RE: Colusa Generating Station (CGS) AFC CEC Docket No. 06-AFC-9

Responses to Data Requests 130 Through 136

Application for Certification (06-AFC-9) for COLUSA GENERATING STATION Colusa County, California

FIGURE 135-1

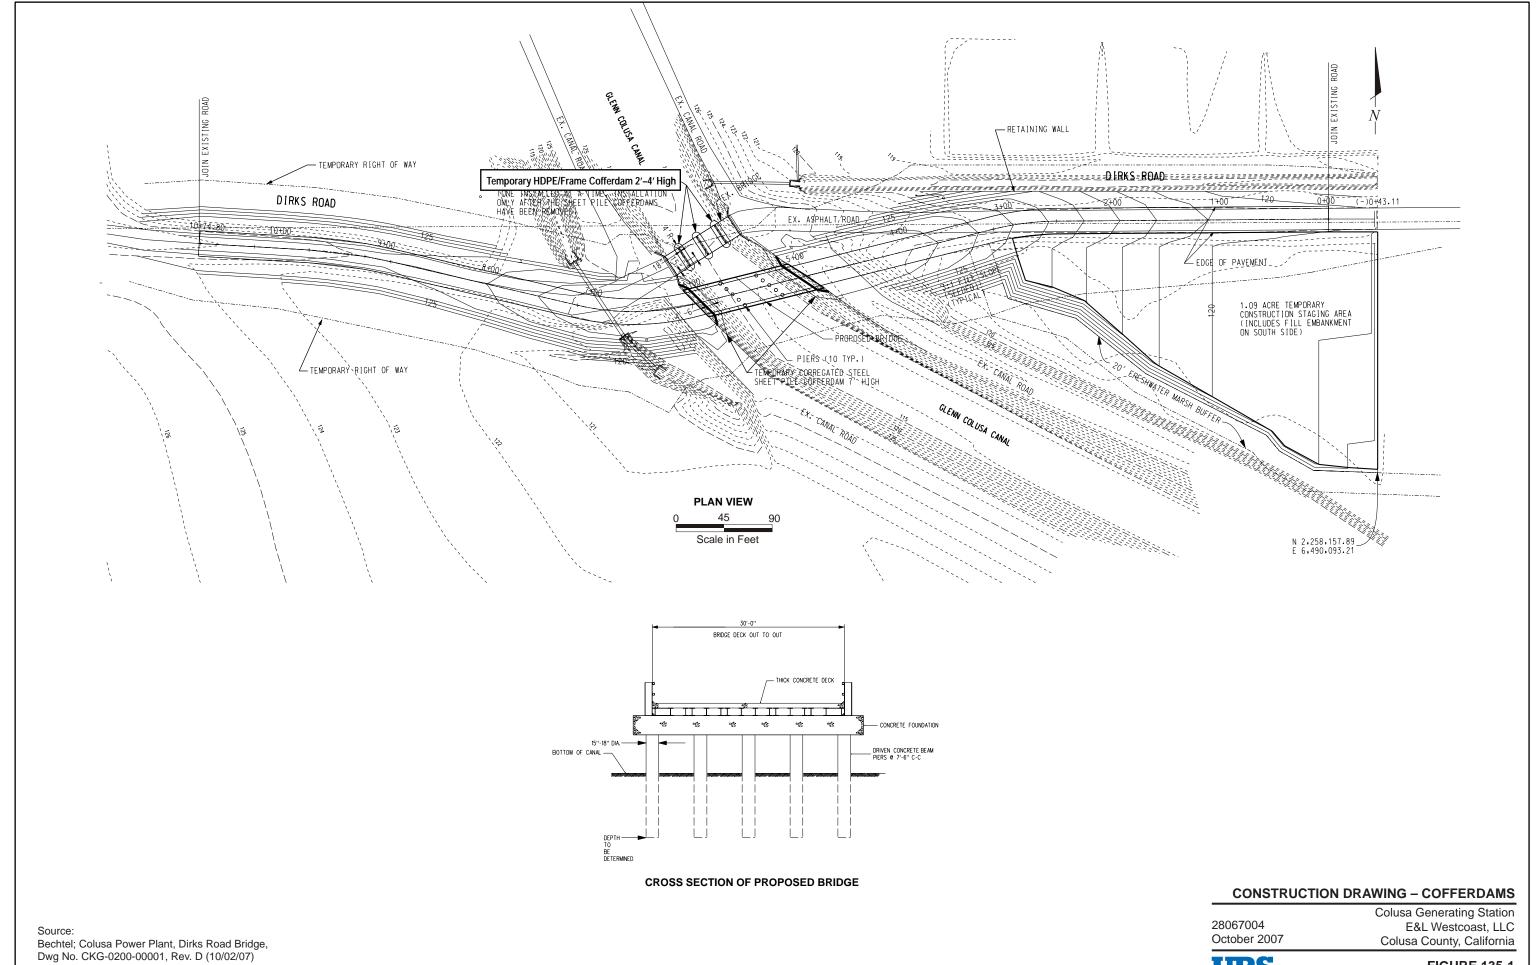
- 135. Provide a more detailed description of the construction procedures and design of the cofferdams to include:
 - the volume of fill material required for the cofferdams
 - the location of the borrow pit where the fill material is to come from
 - preliminary construction drawing showing the height, width, and length of the cofferdams.

The current proposal is to construct a replacement bridge to the south of the existing bridge rather than to the north. The east approach will be located approximately 75 feet south of the existing bridge, and the west approach will be located about 45 feet south. Similar to the previous proposal, the access road on both sides will be realigned to straighten and widen the approaches to allow for unimpeded two-way traffic, re-aligning with the current Dirks Road right-of-way as soon as practical. A retainer wall will be placed along the northern side of Dirks Road, on the east side of the replacement bridge, to enable the continued use of the current irrigation canal.

The replacement bridge will be approximately 100 feet long by 30 feet wide and will be a three-span bridge (rather than a free-span design as previously proposed). Two rows of five driven piers will be constructed in the canal to support the bridge. Corrugated steel sheet piles will be installed to construct a temporary cofferdam around each bridge abutment, as required by the depth of water, to construct the abutments in the dry. The cofferdams will be placed as close as possible to the abutment construction area to minimize the impact to the natural flow of the canal water. If need be, only one cofferdam will be installed at a time. The inside of the cofferdam will be dewatered using a pump or pumps, and the water will be released back into the canal downstream of the cofferdam. Figure 135-1 provides a representation of the cofferdams. The height of the cofferdam will be as needed to envelope the bridge abutment based on the depth of water. This will be determined prior to the start of construction based on the time of year and canal operations during the construction period.

The bridge piers will be driven pre-cast concrete or drilled cast-in-place concrete. They will be installed by equipment located on the canal embankment and can be installed even during high water levels without the use of cofferdams around the pier locations.
